COMMENT STATEMENT OF CONGRESSMAN STEPHEN F. LYNCH,
MASSACHUSETTS SENATOR WALTER F. TIMILTY,
MASSACHUSETTS REPRESENTATIVE WILLIAM J. DRISCOLL, JR.,
BOSTON CITY COUNCILOR ANDREA J. CAMPBELL,
BOSTON CITY COUNCILOR RICARDO ARROYO,
AND
THE MILTON SELECT BOARD

November 19, 2020

These comments and supporting appendix are submitted by the undersigned federal, state, and municipal elected officials regarding the FAA's proposed Logan Airport Runway 4L Environmental Assessment announced on September 15, 2020, with Comment Period running from September 21, 2020 to November 20, 2020.

Figure 41. Approach L_{MAX} Contour Widths for 7 Fleet Types Following Radar Median Approach Profiles

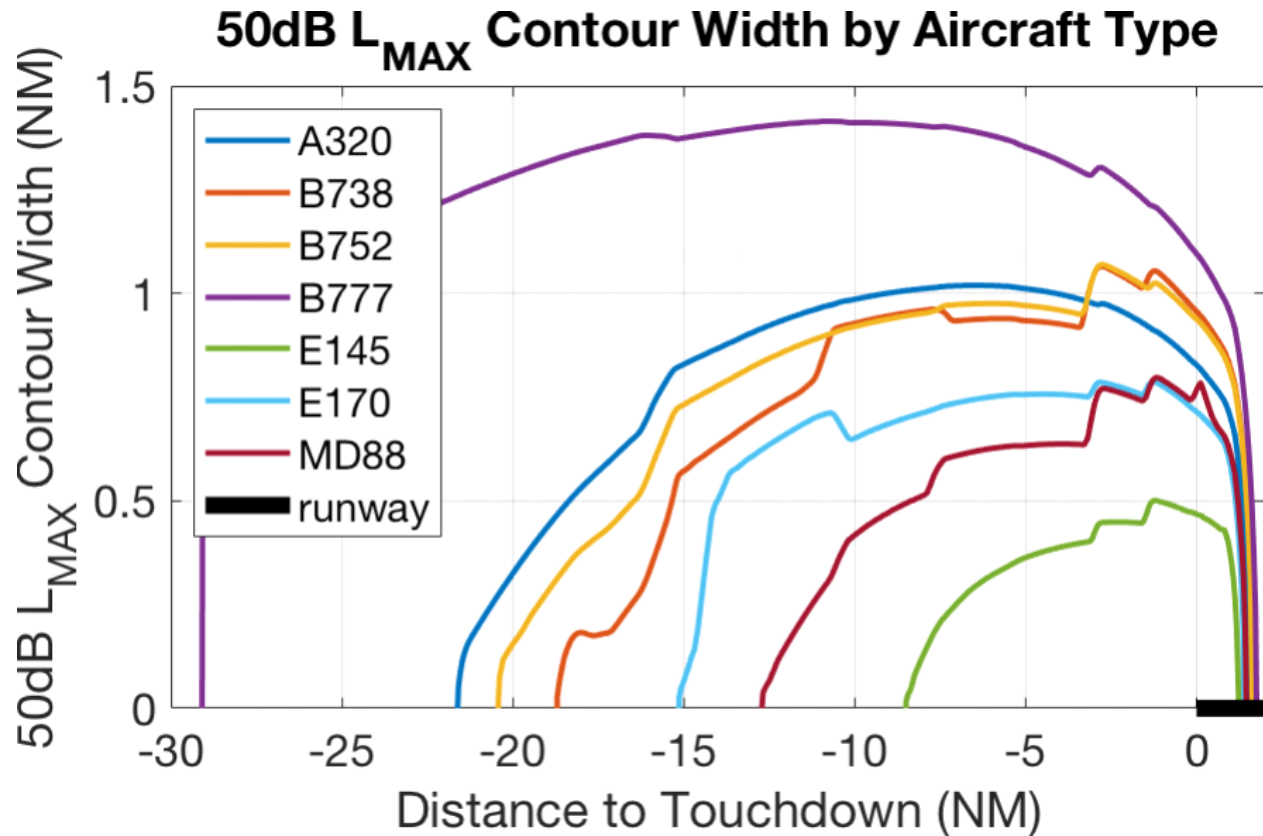
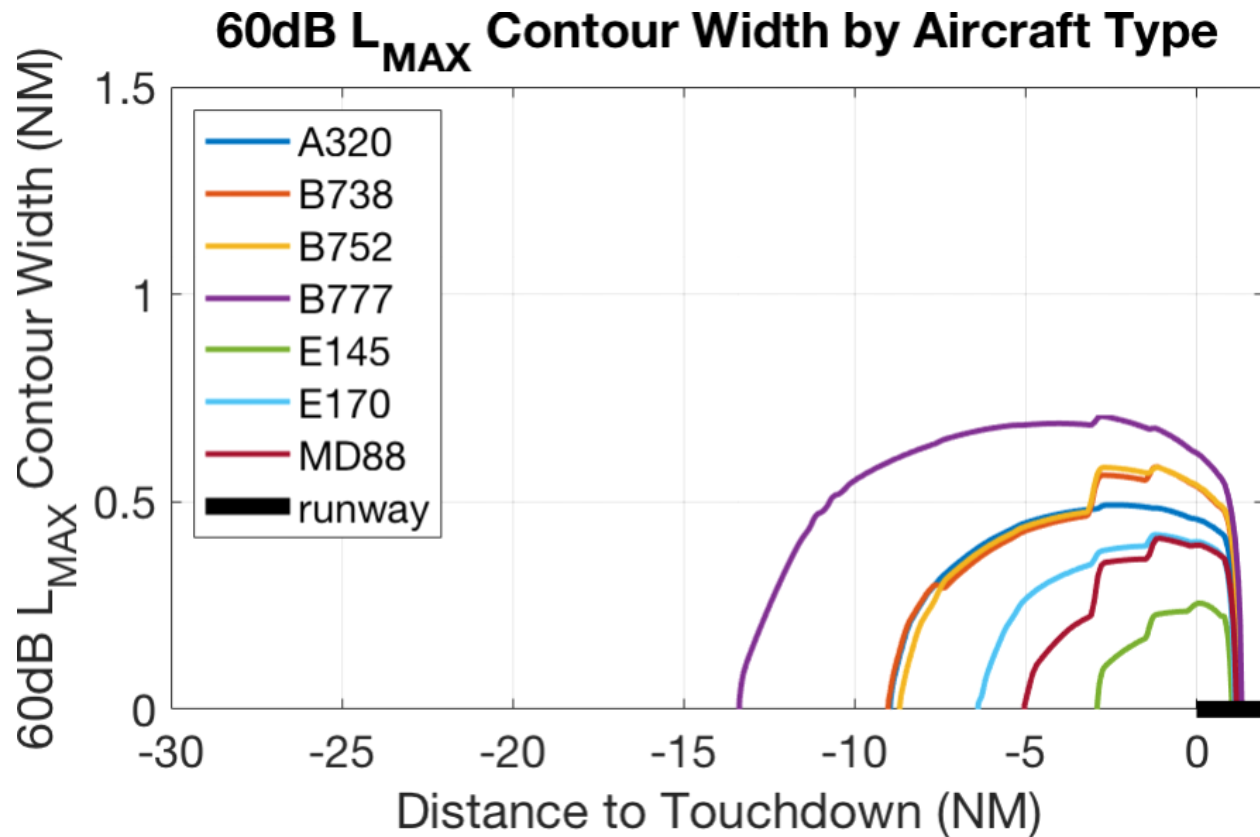
1. that planes proceeding along the 4L path create so-called **noise contours** that reach to the west and east side of each plane; and
2. by doing so, they extend 4L noise to the west of the path and 4R noise to its east; but also by extending 4L noise to the east toward the 4R path, and 4R noise to the west toward the 4L path create a **noise overlap** between the 4L and 4R paths increasing noise occurrence, intensity and duration in that between-CSCRs overflight area.

MIT identified aircraft noise contours as part of its work on the Massport-FAA study referred to earlier in these Comments. The following MIT diagram shows that from distances 15 nautical miles and less to touchdown many aircraft (each identified by type) generate noise contours of

50 and 60 decibels a mile wide (50 decibels) and half a mile wide (60 decibels). That contour width is wide enough to spread across the area between the proposed 4L RNAV and extant 4R RNAV flight paths as planes overfly residential Milton.

The foregoing paragraphs are prelude to this statement: the Draft EA's scope of analysis addresses none of the foregoing 4L/4R CSPR noise realities. Indeed, runway 4R is mentioned in the Draft EA at its Section 2.1.2 which only states its procedure elements, and in its Section 2.2.2.3 which exclusively addresses aircraft-to-aircraft wake turbulence issues created by 4L/4R closely spaced parallel flight tracks **without** any analyses of 4L/4R closely spaced parallel noise turbulence effects on residents.

Please provide supplement the Draft EA to include disclosure focused on the objectively material combined impacts of aircraft traversing the proposed 4L and extant 4R RNAV approach paths (and their Visual and ILS counterparts) on residents, schools, hospitals, churches and other noise sensitive areas under and adjacent to those CSPR paths.

- (1) that planes proceeding along the 4L path create so-called **noise contours** that reach to the west and east side of each plane; and*
- (2) by doing so, they extend 4L noise to the west of the path and 4R noise to its east; but also by extending 4L noise to the east toward the 4R path, and 4R noise to the west toward the 4L path create a **noise overlap** between the 4L and 4R paths increasing noise occurrence, intensity and duration in that between-CSPRs overflight area.*

Figure 2 – Contribution to the overall noise emission of a typical long-range jet airplane during the landing phase

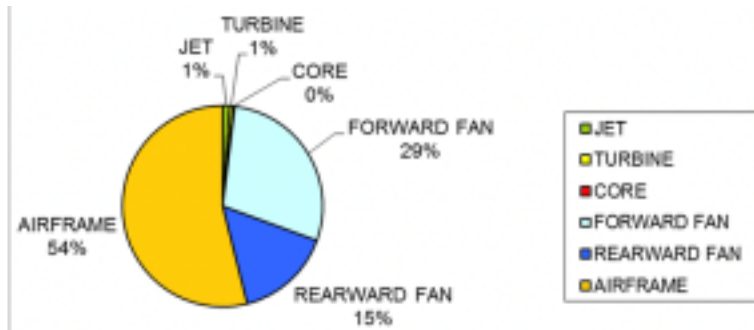
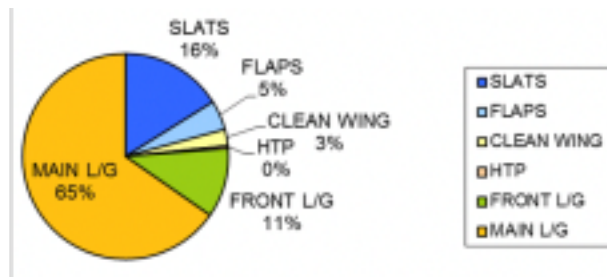
Lowered landing gear of long range aircraft approaching between the IF and FAF, contributing approximately 40% of total noise emitted by those long-range aircraft, is not accounted for in the FAA's noise model used in connection with its EAs. The FAA's modeling assumes only that landing gear are lowered as planes pass by the certification location.

Noise from deployed landing gears at higher speeds (i.e., when the aircraft is between the IF and FAF) is not measured as part of an aircraft's noise certification process and not incorporated into the AEDT noise model. Each aircraft's speed between the IF and the FAF, and the differential noise effect of higher speed at IF and thereafter, with landing gear deployed prior to FAF as the plane approaches is **not reflected in the FAA's EA model.**

For a typical long-range airplane during the approach phase, around 54% of the noise stems from the airframe. Out of these 54%, 76% originate from the landing gear alone (see Figure 2 and Figure 3).

In total, the landing gear accounts for about 40% of the total noise emissions of a long-range airplane in approach conditions.
